**Change Notification #:** 112315 - 00  
**Change Title:** Intel® Server Chassis P4304XXSHCN  
PCN 112315-00, Product Design  
Update Cables  
**Date of Publication:** May 23, 2013

Intel factory will implement the following changes on the Intel® Server Chassis P4304XXSHCN.

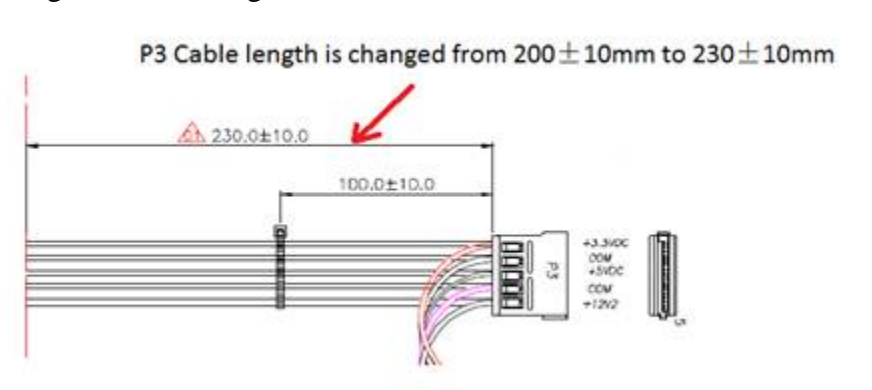
1. Change the cable length of P1 from 170mm to 290mm.

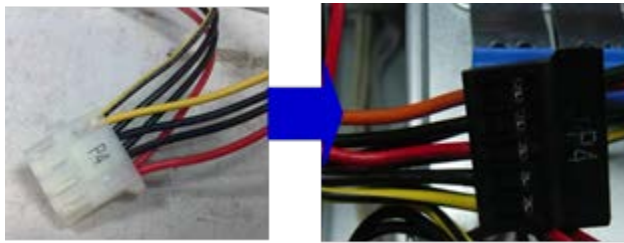
2. Change the cable length of P3 from 200mm to 230mm.
